Project information table with columns for customer (IOWA ELECTRIC), project name (DUANE ARNOLD ENERGY CENTER), sheet number (E8-5229-18), and date (1-9-82).

DCP PACKAGE INDEX ITEM NO. 6.3.10

CONNECTION DIAGRAM - REMOTE SHUTDOWN PANEL PANEL IC388 table with columns for wire number, description, and status.

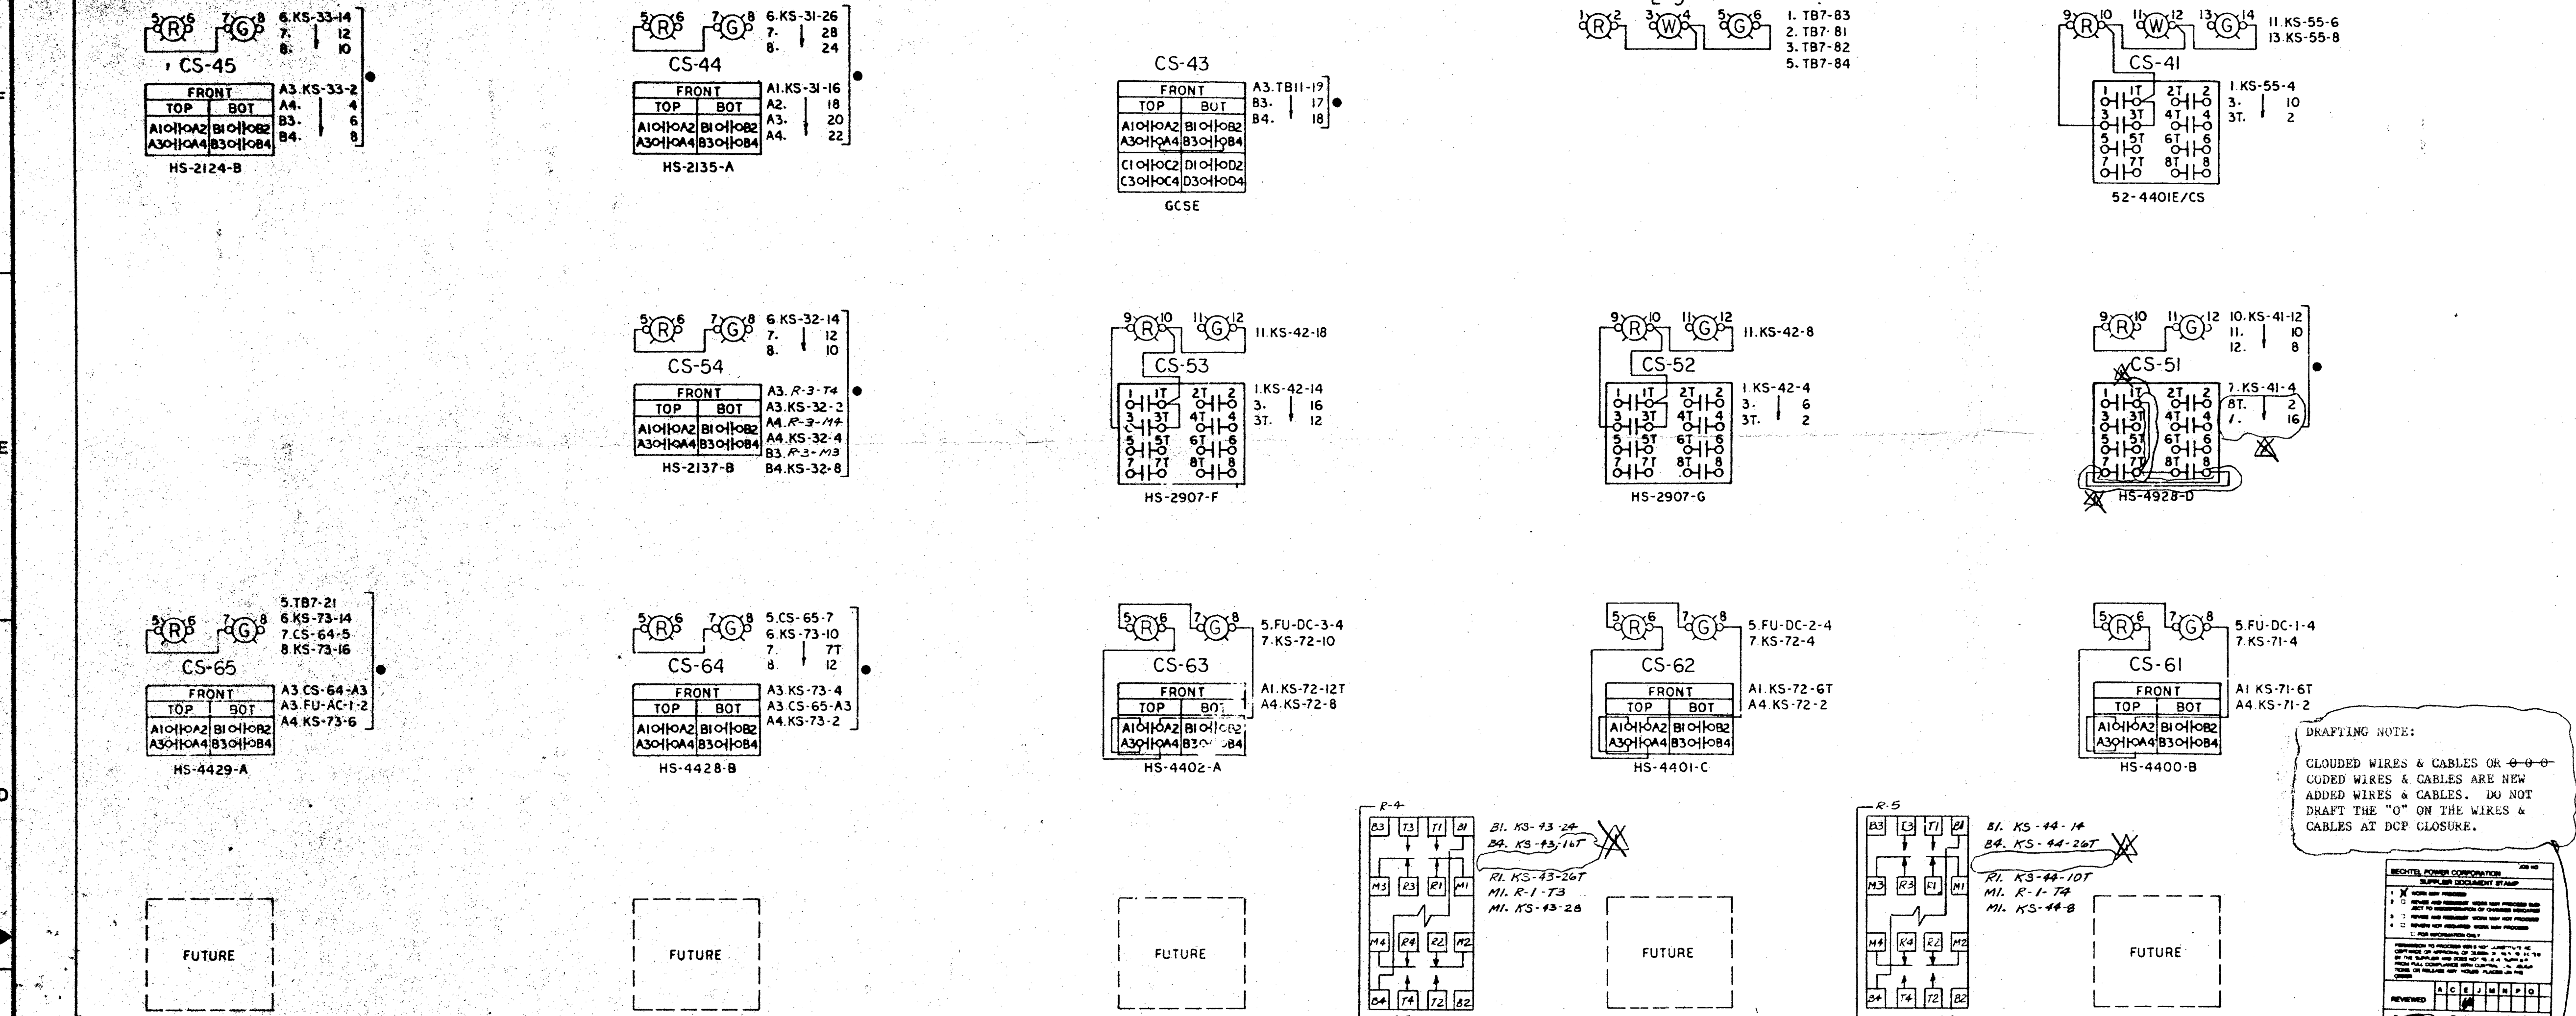
DRAFTING NOTE: CLOUDED WIRES & CABLES OR Coded WIRES & CABLES ARE NEW ADDED WIRES & CABLES. DO NOT DRAFT THE 'O' ON THE WIRES & CABLES AT DCF CLOSURE.
